ATTACHMENT 2

October 21, 2005

Subject: UNC-Cogeneration Facility – Special Use Modification (File No. 792.H.2)  
Response to Questions for Town Council

**WELL LIGHTING**

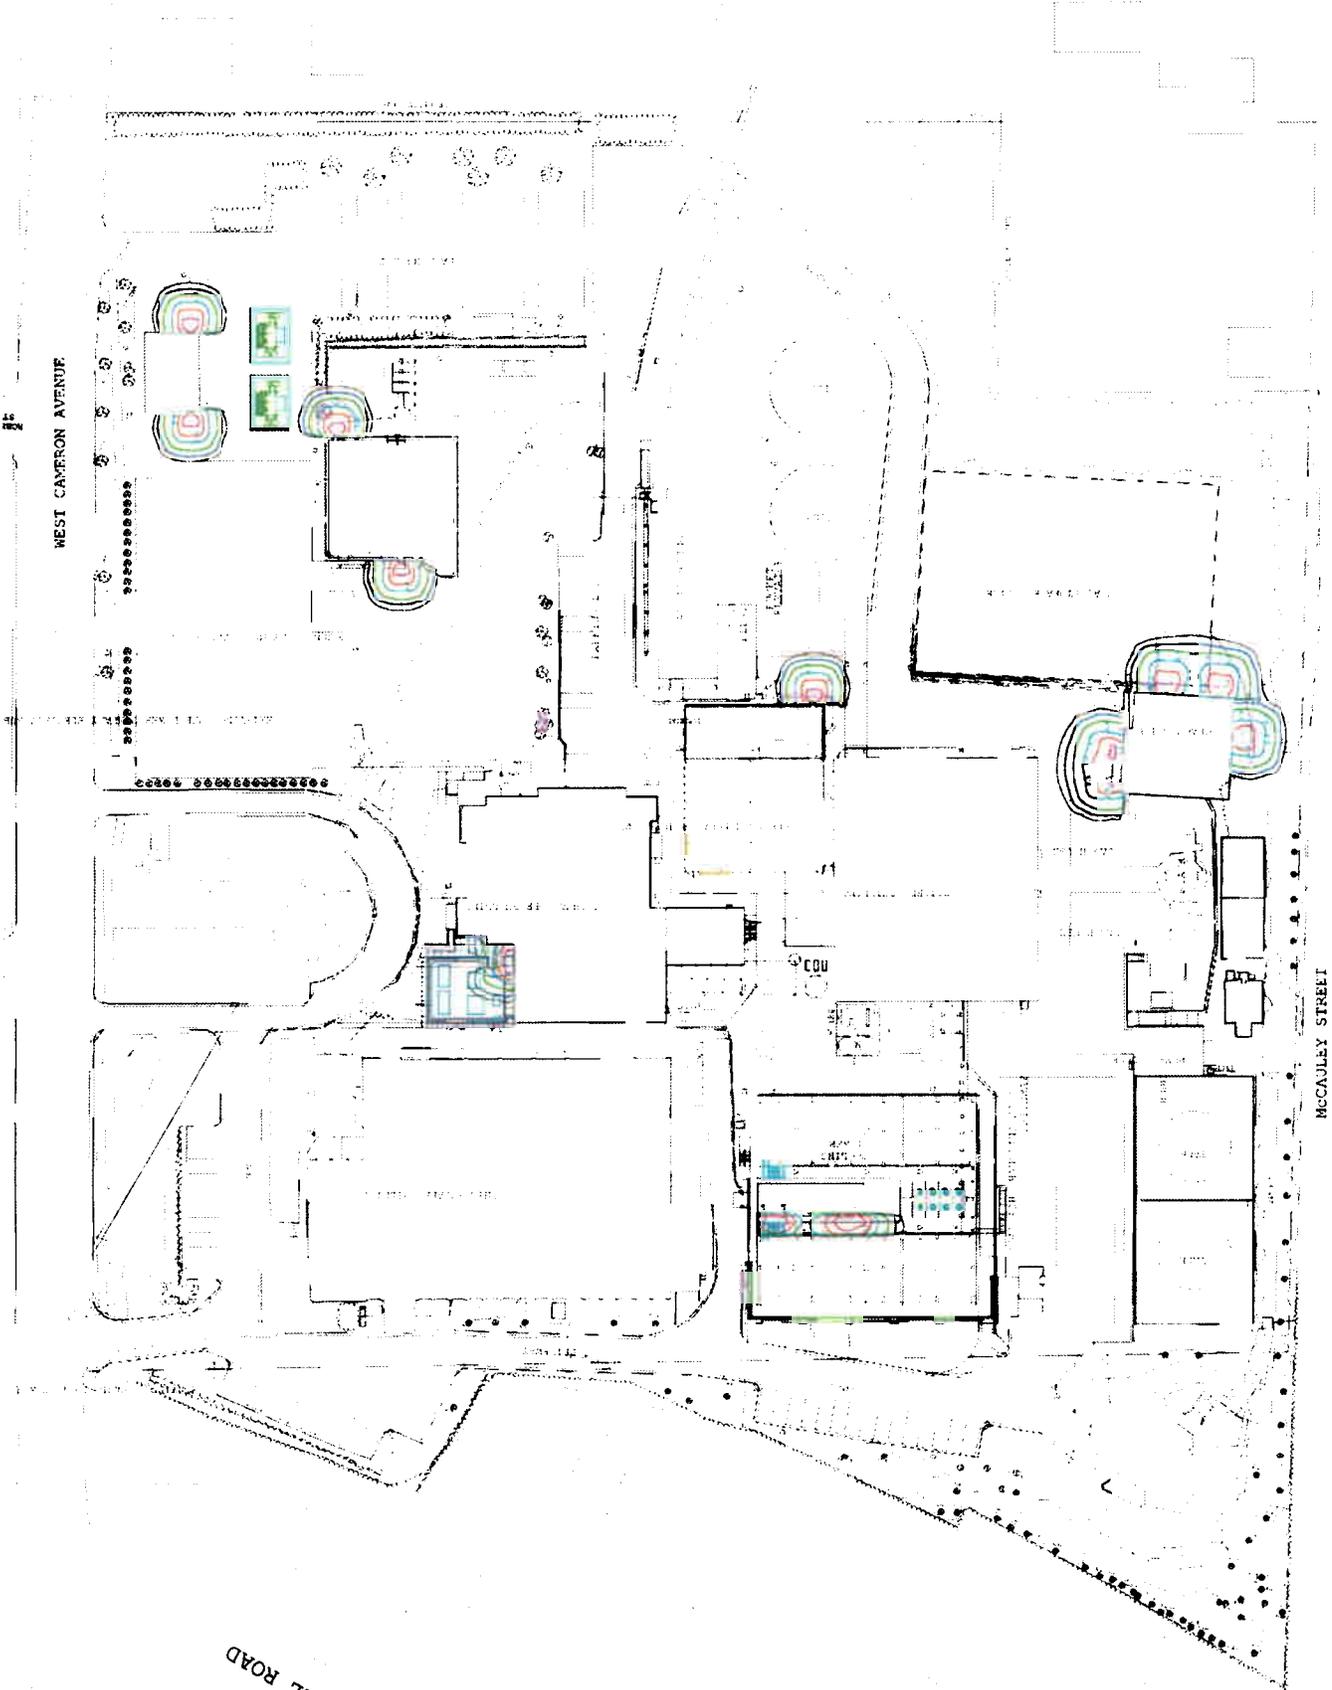
**4. Please describe any proposed lighting improvements. What is the projected incremental change in light from current light levels, with the proposed plant upgrade? Please provide an isometric lighting plan, if possible.**

**UNC Response:** There will be no net change in light levels at any Cogen Facility property line. Approximately 15 new exterior light fixtures are being added as part of the Cogen SUP projects (See the isolux contour map attached). These lights will be located over doorways in 8 visible locations on the site and are required to ensure safe ingress/egress at night. The other lights will be interior to the cooling towers and the generator yard. These lights will be on during hours of darkness. Approximately 15 additional lights will also be installed with these upgrades but they are task related and will normally be switched off. These task lights will only be turned on when required for emergency maintenance or repairs.
